# Addendum No. 1 to Environmental Impact Report

## Carpinteria Advanced Purification Project

**October 2024**

Figure 1-2: Modified Project

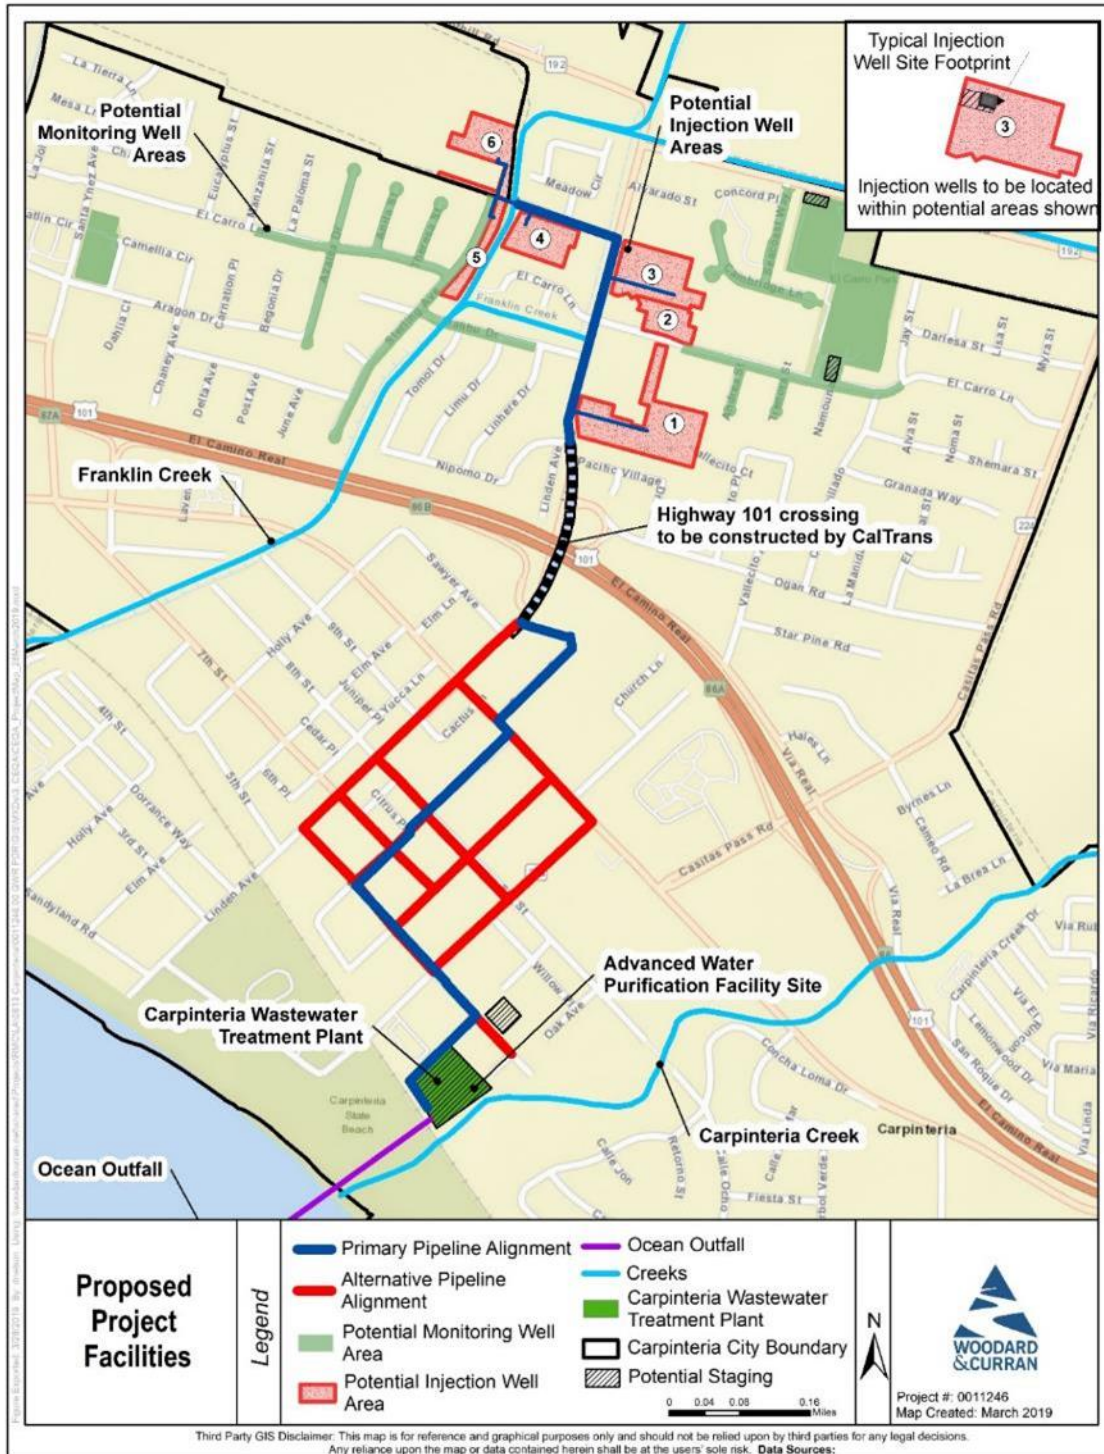
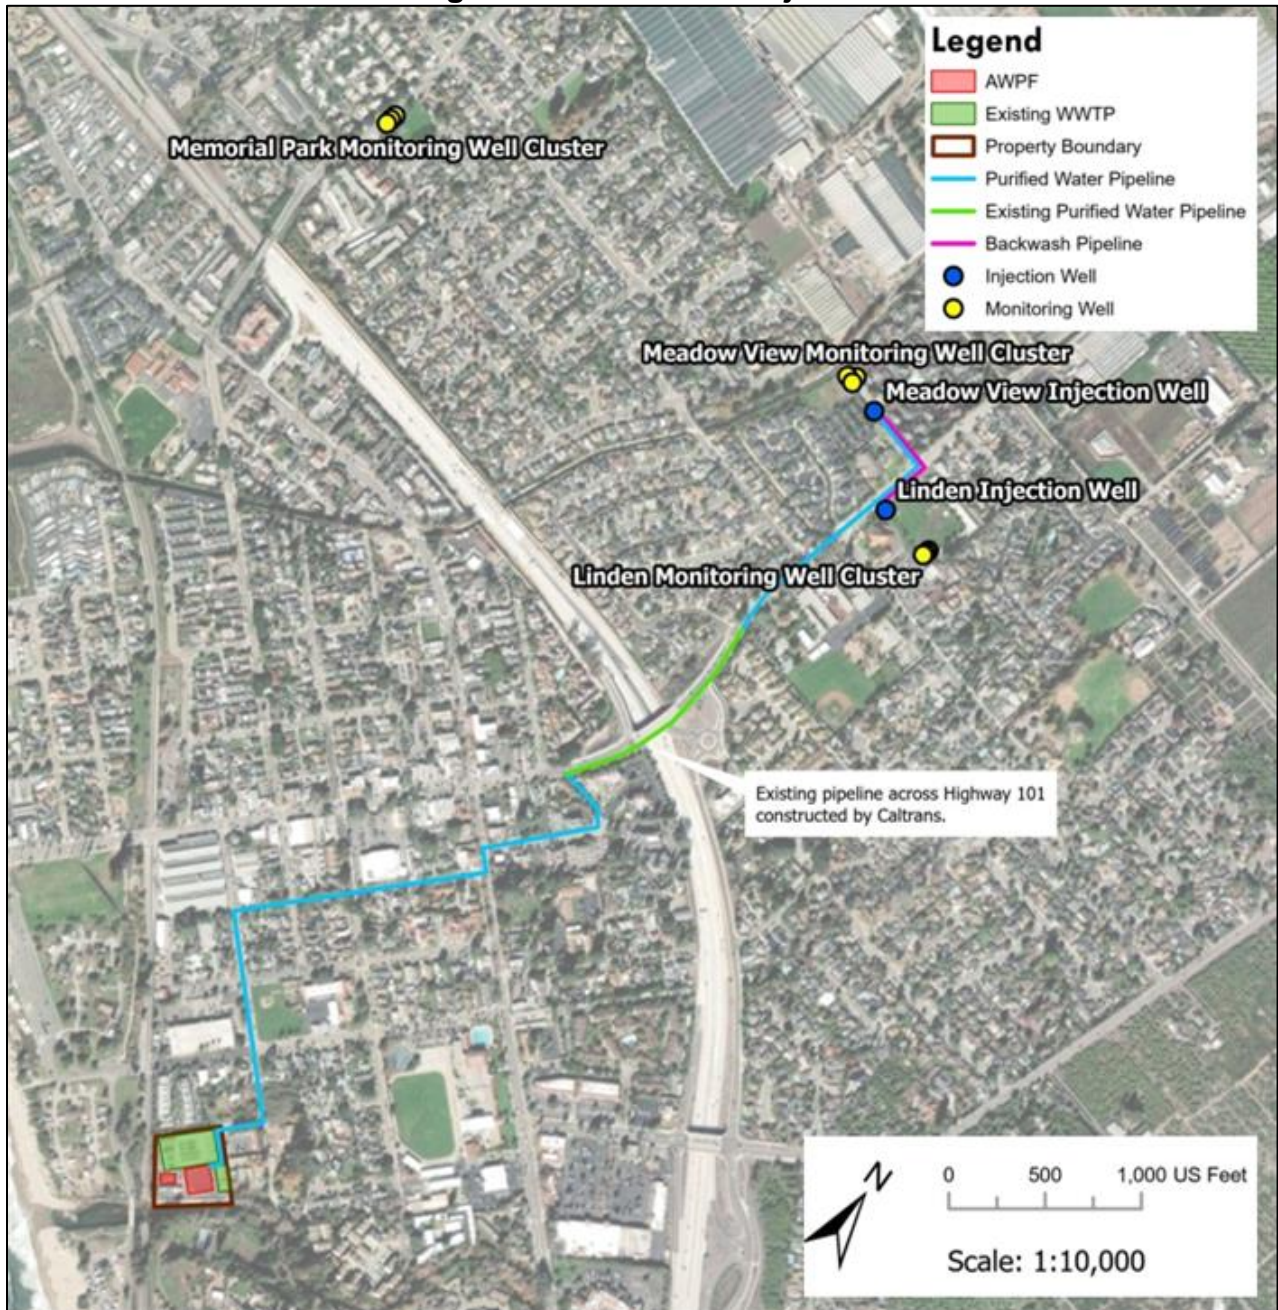
The Modified Project is considering alternative locations for the injection well proposed for Well Site #3, which is now referred to as the Linden Injection Well under the Modified Project. The Modified Project maintains the potential placement of the well at the corner of the parcel near Linden Avenue as described in the EIR, but includes a new potential location for the well in the roadway ROW on Linden Avenue, approximately 250 feet north of the intersection of Linden Avenue and El Carro Lane. This well would have a similar size and depth as originally described in the Approved Project and would be constructed in the same manner as originally approved, though the wellhead would be located below-ground in a manhole instead of a below-ground vault. Above-grade appurtenances and electrical controls will be located inside a fenced enclosure within the ROW along the sidewalk or within the parcel.

The Modified Project includes an alternative location for the injection well at Well Site #4. The new location would be the roadway ROW on Meadow View Lane adjacent to the Well Site #4 parcel, owned by the Church of Latter-day Saints. The new location would be located approximately 350 feet west of the intersection of Meadow View Lane and Linden Avenue. This well would have a similar size and depth as originally described in the Approved Project and would be constructed in the same manner as originally approved, though the wellhead would be located below-ground in a manhole with above-grade appurtenances and electrical controls located behind the sidewalk in the roadway ROW. Above-grade equipment will be inside a fenced enclosure within the ROW along the sidewalk. Restoration to sidewalk and paving is subject to City permitting. The addition of the Meadow View Lane ROW as a proposed location for the injection well does not change the total number of injection wells planned for the project. Under the Modified Project, there would no longer be a backwash storage tank constructed at Well Site #4. Instead, a buried pipeline is proposed that will be sufficient in size to convey the injection well backwash to the sewer collection system, eliminating the need for the above-ground storage tank. This buried 48-inch pipeline in Meadow View Lane will allow for the backwash to be conveyed to the sewer system along Linden Avenue and returned to CSD's water reclamation plant for advanced water purification back into the groundwater system. Staging and soundwalls may be located on existing paved surfaces within 50 feet of the Franklin Creek embankment, though the environmental commitments included in the EIR, including compliance with permit requirements (including implementation of a Stormwater Pollution Prevention Plan) and keeping the areas clean of trash and debris, would be implemented to avoid potential impacts to the creek.

The Modified Project would expand the potential locations for monitoring well clusters to include injection Well Site #2 and injection Well Site #3 of the Approved Project, the roadway ROW at the western end of Meadow View Lane (adjacent to injection Well Site #4), as well as to CVWD headquarters at 1301 Santa Ynez Road and the adjacent roadway ROWs. The total number of monitoring wells, size, depth, and construction methods would remain the same as the Approved Project, with up to four monitoring well clusters being constructed for the Project, though one monitoring well cluster at El Carro Park has already been constructed and is not included in this analysis. **Figure 1-2** shows the expanded locations to be considered for monitoring wells based on final design, modeling, and permitting requirements.

The area where monitoring wells would be located has been expanded from the areas identified in the EIR and now include the Well Site #2 and Well Site #3 parcels, as well as the roadway ROW adjacent to Well Site #4, at the western end of Meadow View Lane. The Modified Project retains the potential monitoring well locations included in the EIR, which are shown in **Figure 1-1**. The expanded monitoring well locations are shown in **Figure 1-2**.

**Figure 2-4: AWPf Site Layout under Modified Project**

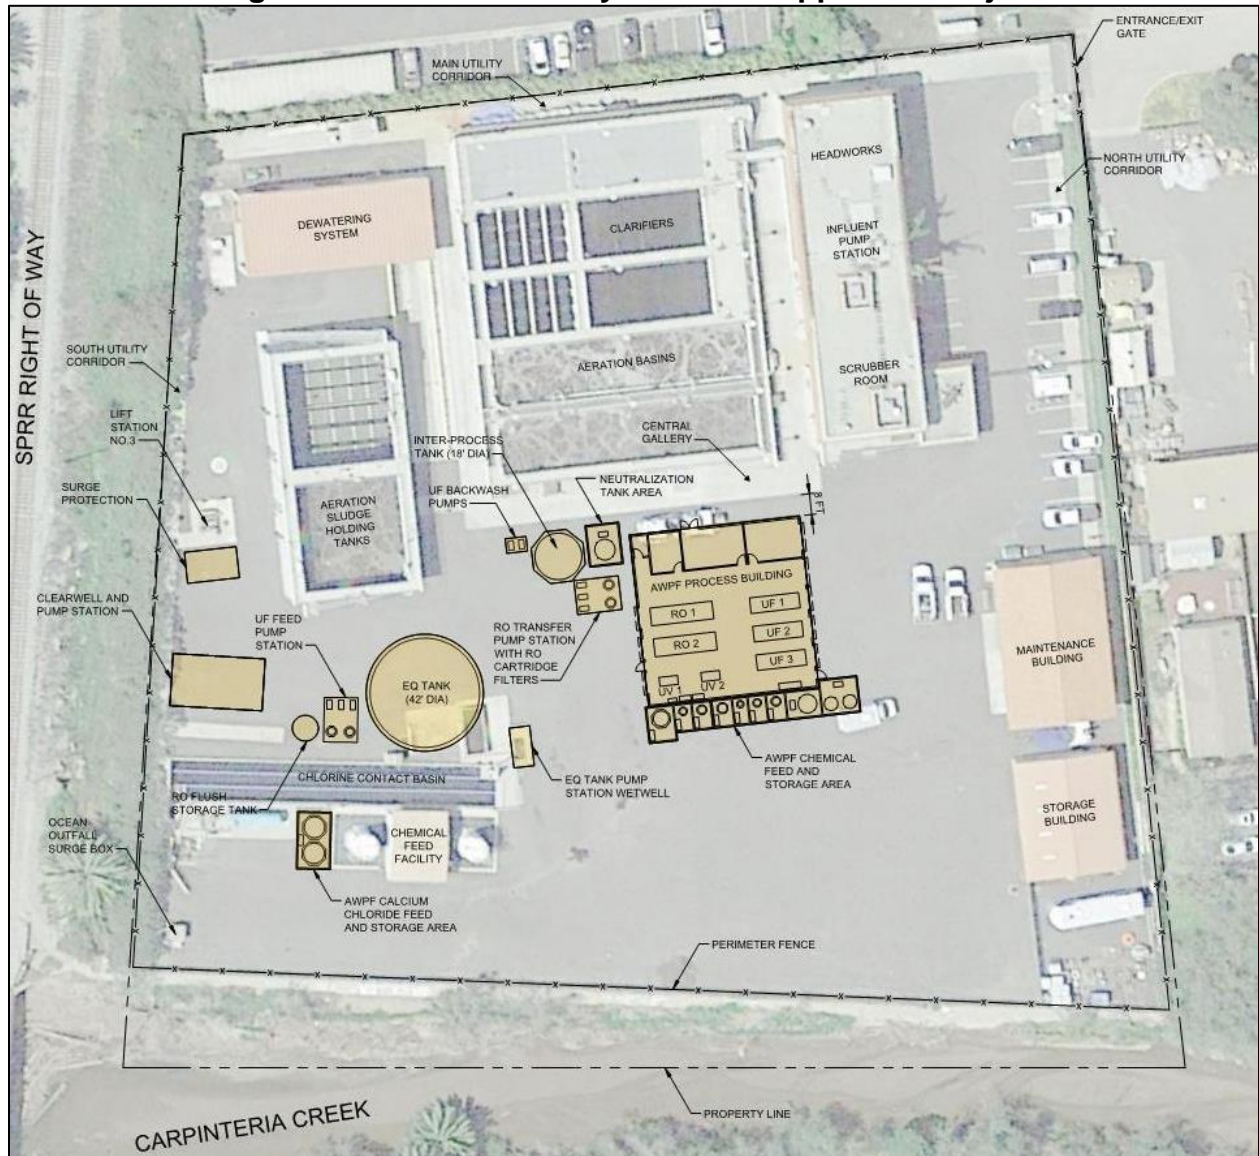
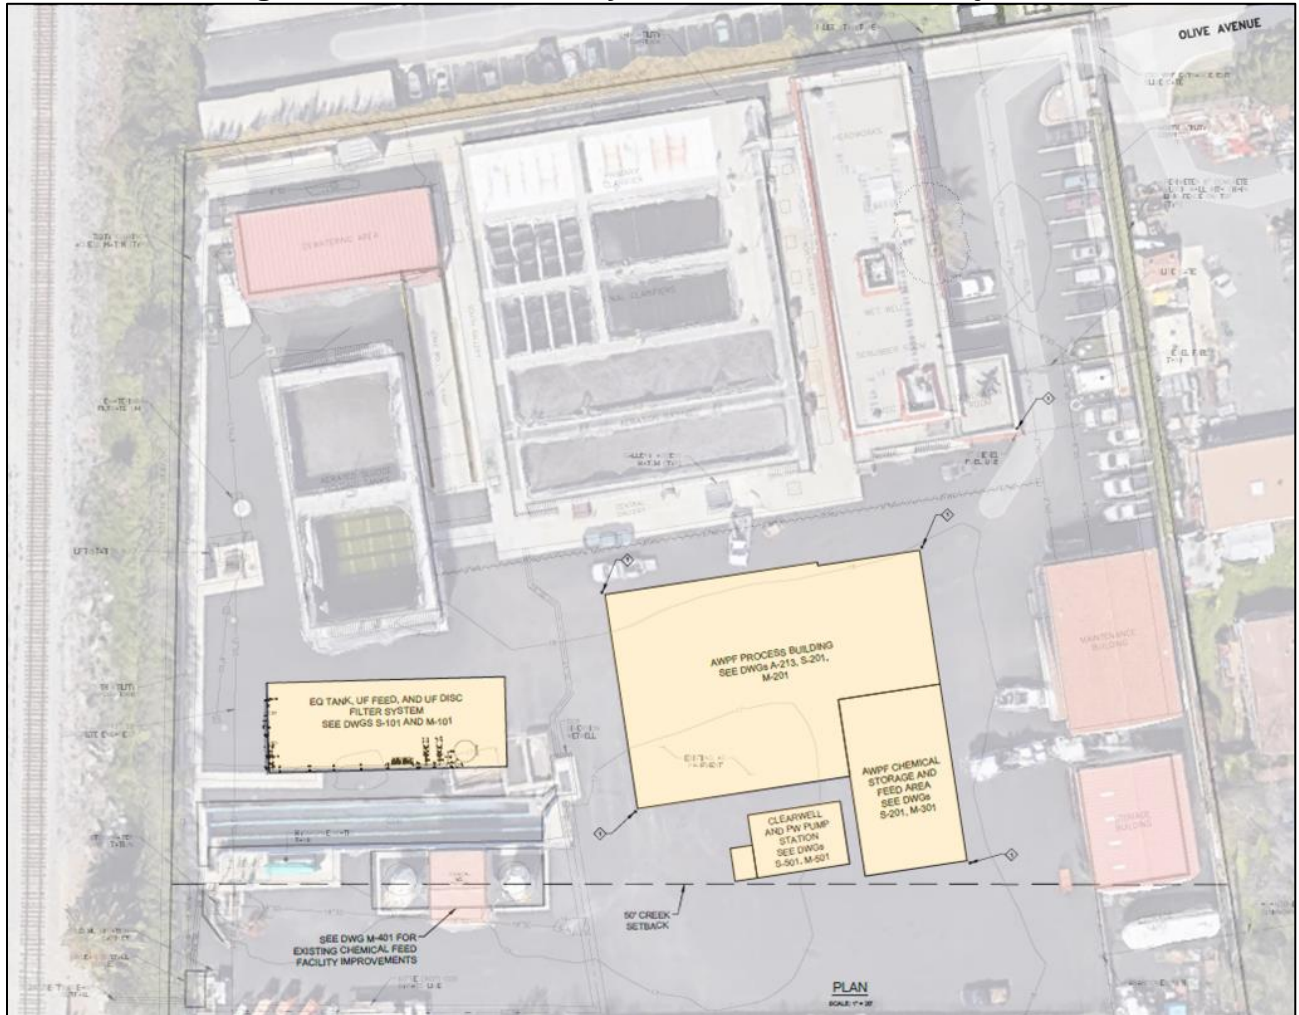
Under the Modified Project, the AWPf layout would be modified. Specifically, the AWPf Process building would be 12,000 square feet compared to 8,900 square feet under the Approved Project, with the enclosed AWPf Process Building at approximately 8,300 and chemical storage area and UV reactor outside under a 3,700 square foot canopy. The chemical storage and feed area would be moved from spanning the width of the building to occupying a corner of the building. The clearwell and purified water pump station would be moved from the southern side of the site to the southwest side of the AWPf Process Building to be located under the UV reactor canopy. The equalization tank, UF feed, and UF disc filter system would be located in approximately the same location as the Approved Project, but the 200,000gallon equalization tank would be below grade. As with the Approved Project, there would be no new facilities located within the 50-foot setback from the top of the bank of Carpinteria Creek.

Under the Modified Project, the total facilities footprint at the AWPf including the building, clearwell, and equalization tank would be approximately 15,000 square feet, an increase

from the 11,000 square feet included in the Approved Project. Below ground facilities, including the purified water clearwell, waste equalization tank, and equalization tank, would range from 8 feet to 21 feet deep, and the AWPf structure would be 30 feet tall compared to 20 feet for the AWPf process building under the Approved Project. Excavation of up to 21 feet in depth could be required to construct the belowground tanks. As was included in the Approved Project, excavation up to 20 feet in depth may be required to remove an existing buried and abandoned circular primary clarifier (roughly 67 feet outside diameter), located approximately 10 feet west of the proposed AWPf.

Soil stabilization is recommended under the AWPf Process Building. Deep soil mixing has been selected as the preferred approach and produces lower noise levels over a driven pile system or drilled piles, both of which were included in the Approved Project. This change eliminates the use of a pile driver during construction of the Modified Project. Deep soil mixing improves weak soils prone to liquefaction by mixing them with a dry cementitious binder or slurry. A drilling rig is used to drill into the soil to a depth that is to be modified, and cement and water are injected directly into the soil through the mixing blade. This allows the combined soil and cement to be mixed in place with minimal excavation or spoils. The drill auger is then slowly withdrawn to the surface while the cement is simultaneously pumped and mixed into the soil layers. Depth and number of drillings will be subject to final design. Deep soil mixing will be limited to the approximate footprint of the AWPf Process Building, chemical storage area and UV canopies, and clearwell tank under the UV canopy equal to approximately 12,000 square feet. Helical anchors will be utilized for soil stabilization under the equalization tank.

The Approved Project's AWPf layout along with the Modified Project's layout are provided in **Figure 2-3** and **Figure 2-4**. These changes to the AWPf layout would increase the overall aboveground building height from 20 feet in the Approved Project to 30 feet under the Modified Project. A rendering of the AWPf structure under the Modified Project is provided in **Figure 2-5**.
